NINE MILE POINT NUCLEAR STATION, UNIT NO. 1

AMENDMENT TO FACILITY OPERATING LICENSE

Amendment No. 16
License No. DPR-63

SAFETY EVALUATION BY THE OFFICE OF NUCLEAR REACTOR REGULATION
SUPPORTING AMENDMENT NO. 16 TO FACILITY OPERATING LICENSE NO. DPR-63
NIAGARA MOHAWK POWER CORPORATION
NINE MILE POINT UNIT NO. 1
DOCKET NO. 50-220

Figure 3.1.7ff

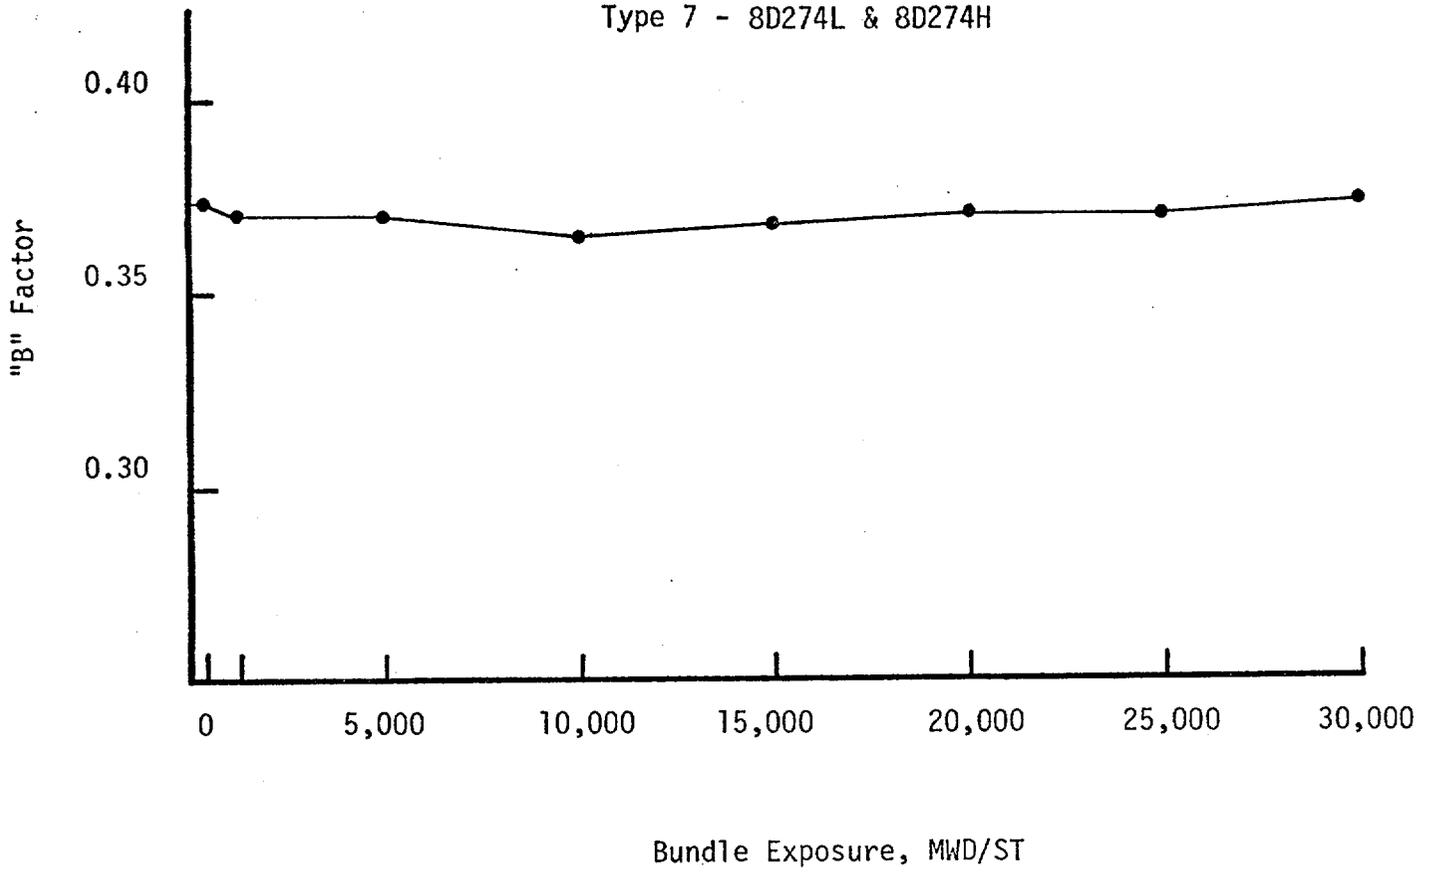
<u>Fuel Type(s)</u>	<u>"B"</u>
Type 1 - initial core	Figure 3.1.7.aa
Type 2 - reload 1	Figure 3.1.7.bb
Type 3 - reload 2	Figure 3.1.7.cc
Type 4 - reload 3	Figure 3.1.7.dd
Type 5 - 8D250	Figure 3.1.7.ee
Type 6 - 8D262	Figure 3.1.7.eee
Type 7 - 8D274L & 8D274H	Figure 3.1.7.ff

Figure 3.1.7.f Maximum Allowable Average Planar LHGR
Applicable to Type 7 Fuel

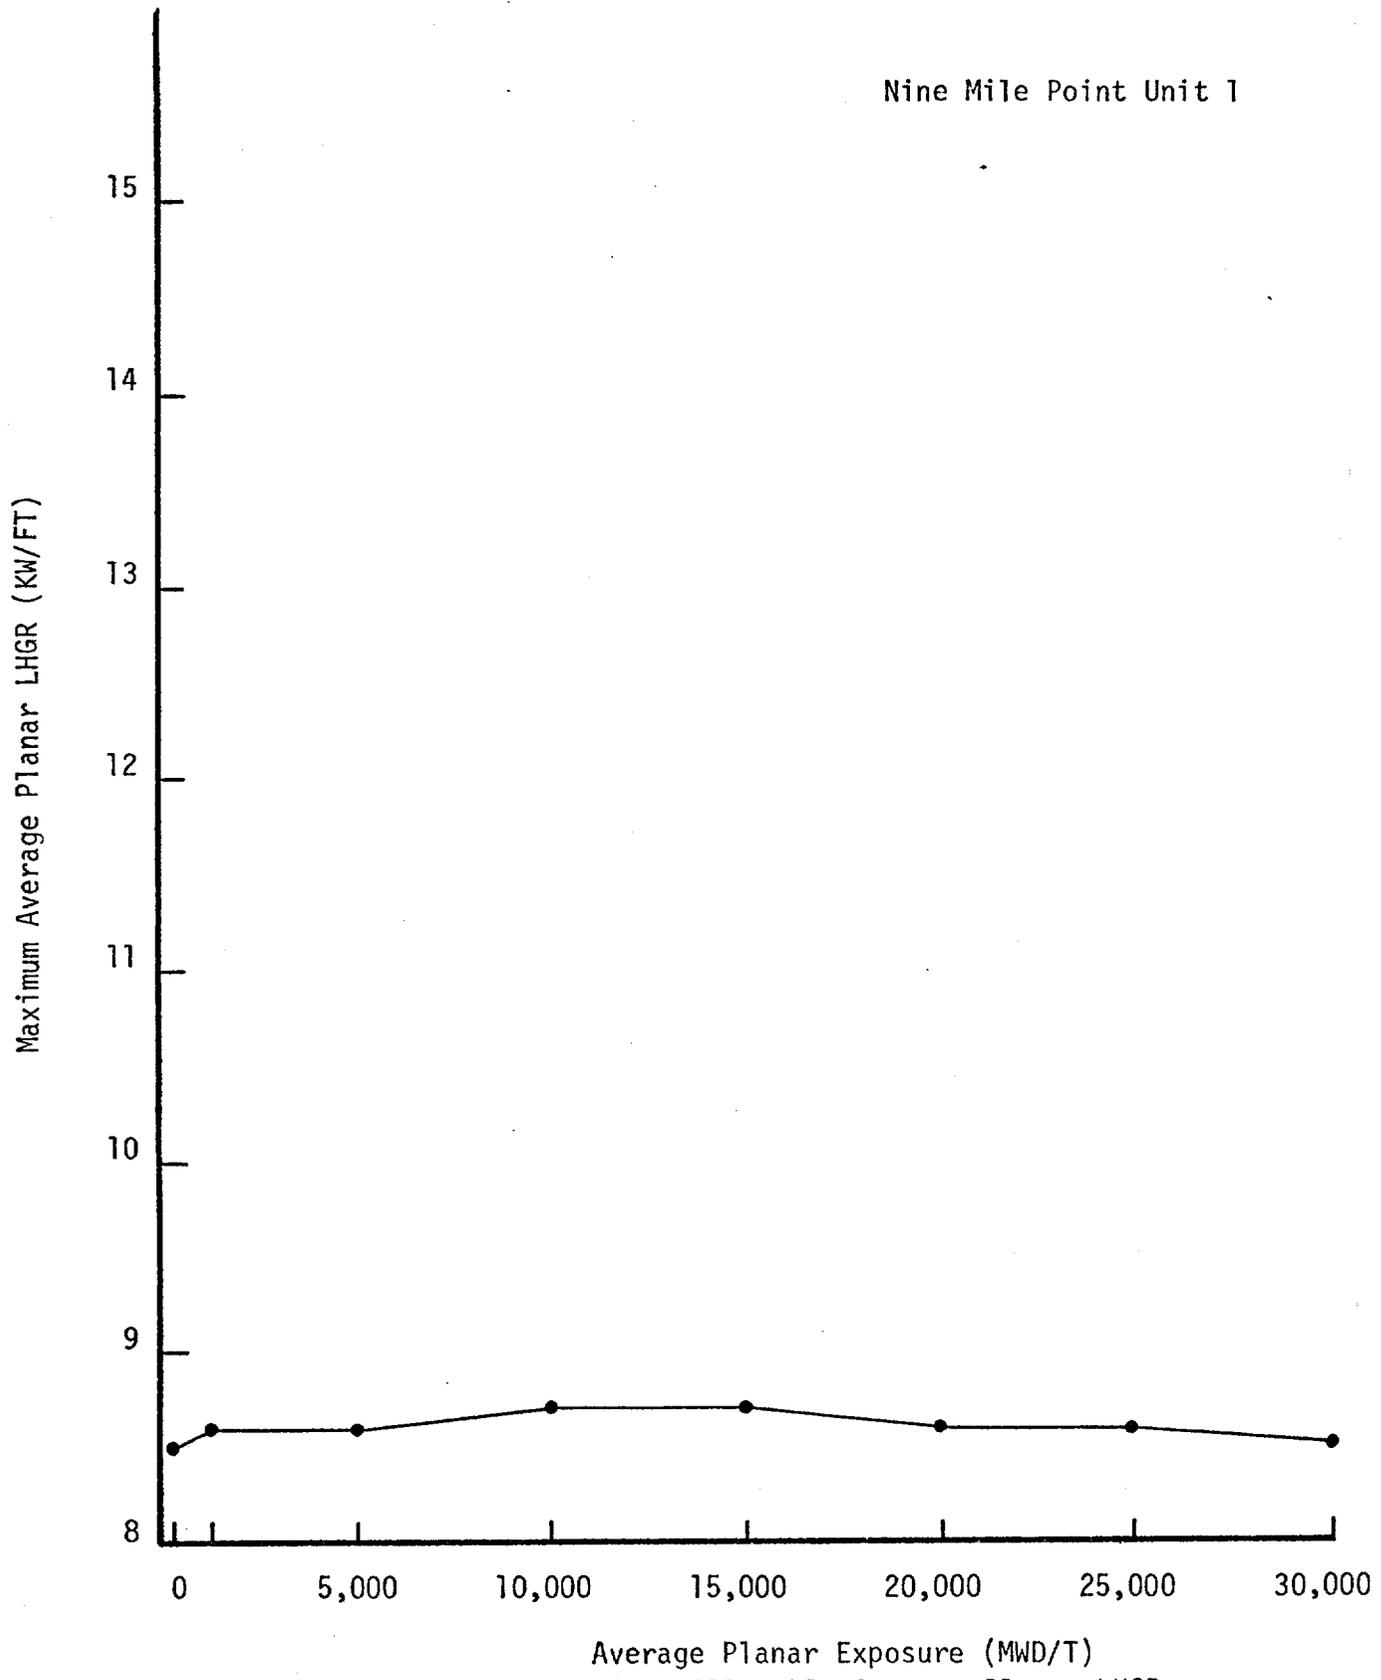
During power operation, the APLHGR for each type of fuel as a function of average planar exposure shall not exceed the limiting value shown in Figures 3.1.7.a, 3.1.7.b, 3.1.7.c, 3.1.7.d, 3.1.7.e and 3.1.7.f. If at any time during power operation it is determined by normal surveillance that the limiting value for APLHGR is being exceeded action shall be initiated within 15 minutes to restore operation to within the prescribed limits. If the APLHGR is not returned to within the prescribed limits within two (2) hours, the reactor shall be brought to the Cold Shutdown condition within 36 hours. Surveillance and corresponding action shall continue until reactor operation is within the prescribed limits.
